GARNETT NETHERWOOD ARCHITECTS
PLOT D5
CYGNET PARK, PETERBOROUGH
for BUSINESS HOMES

Project
Date
15/02/2003
Revision
G
03/04/2001

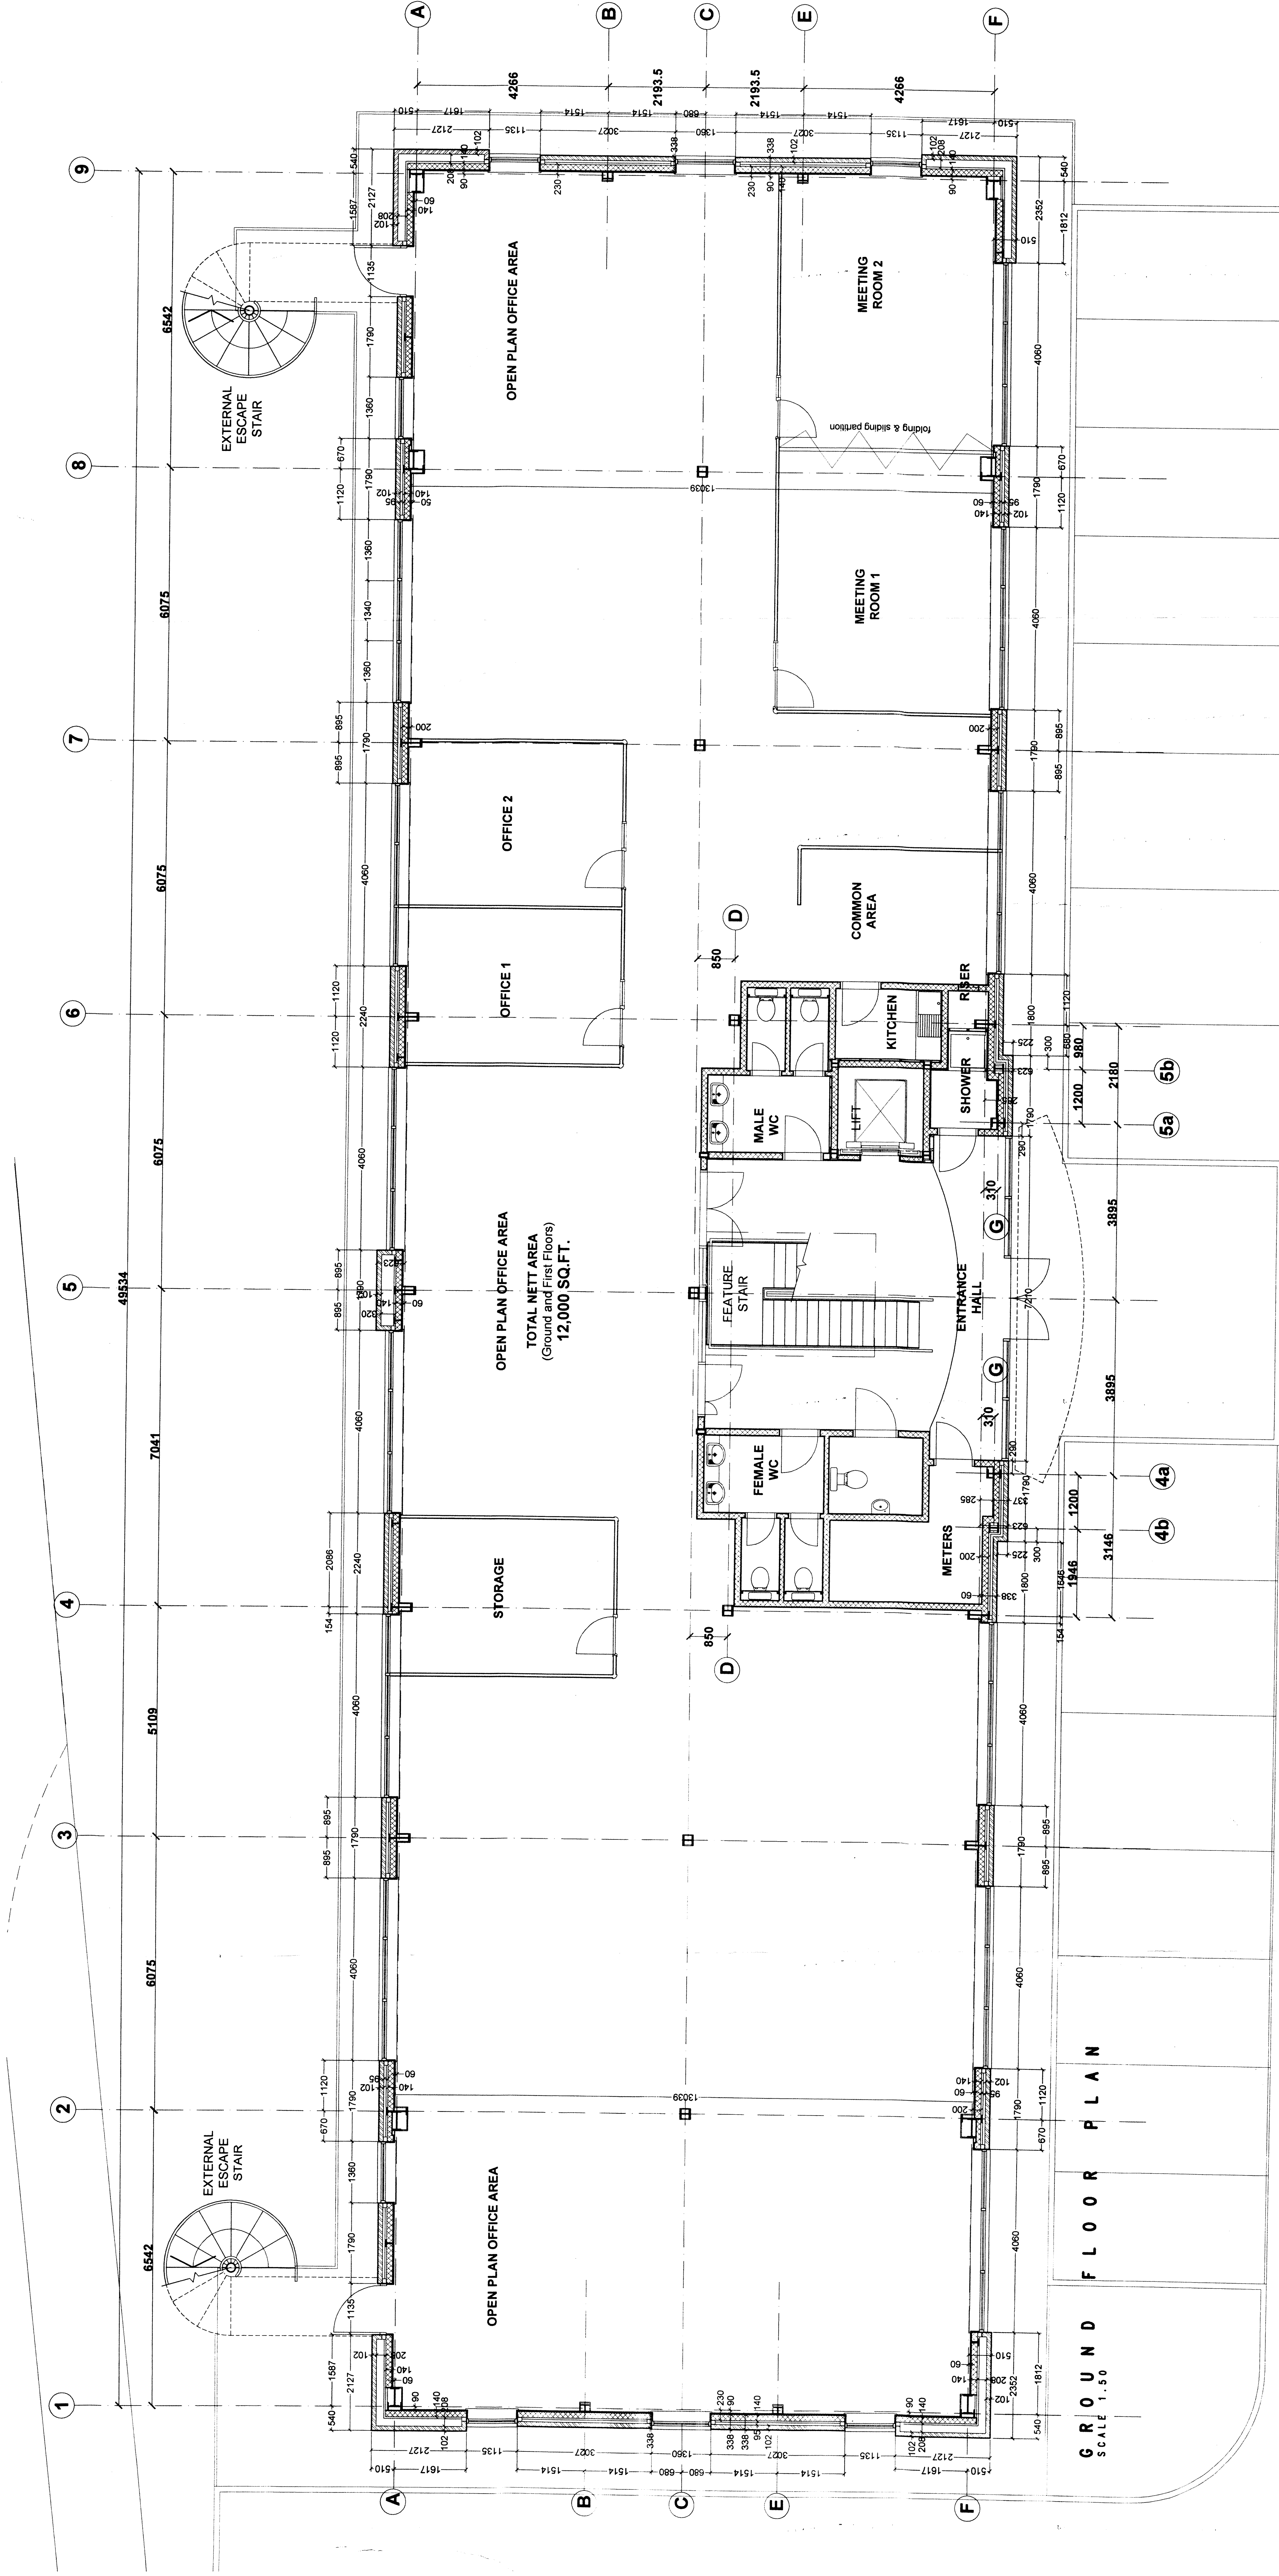
Rev. G - 06/07/03 - Internal entrance hall screen altered following tenant's request and windposts added to match structural engineer's details. J.L.W.
Rev. F - 20/11/03 - Internal partitions shown and thermabile type cavity closers shown to close building corners altered to suit OLS requirements. Internal lead blockwork at building corners altered to suit Structural Engineer's requirements. J.L.W.
Rev. E - 03/11/03 - Lift Stair altered to suit OLS requirements. Internal lead blockwork at building corners altered to suit Structural Engineer's requirements. J.L.W.
Rev. D - 18/08/03 - Entrance hall stair and screen amended to match feature stair drawings. J.L.W.
Rev. C - 03/08/03 - Internal core door altered. J.L.W.
Rev. B - 30/05/03 - Grid Line 6 and relevant steelwork altered to suit structural engineer, door and a half openings shown between office area and entrance and stair altered for revised open tread design. J.L.W.

Rev. A - 29/02/03 - Grids and steelwork altered to match steel drawings. GL A window altered to match elevations. Shower added to ground floor core and kitchen altered to match elevations. Entrance hall stair and screen altered to match elevations and showing additional step to first light. J.L.W.
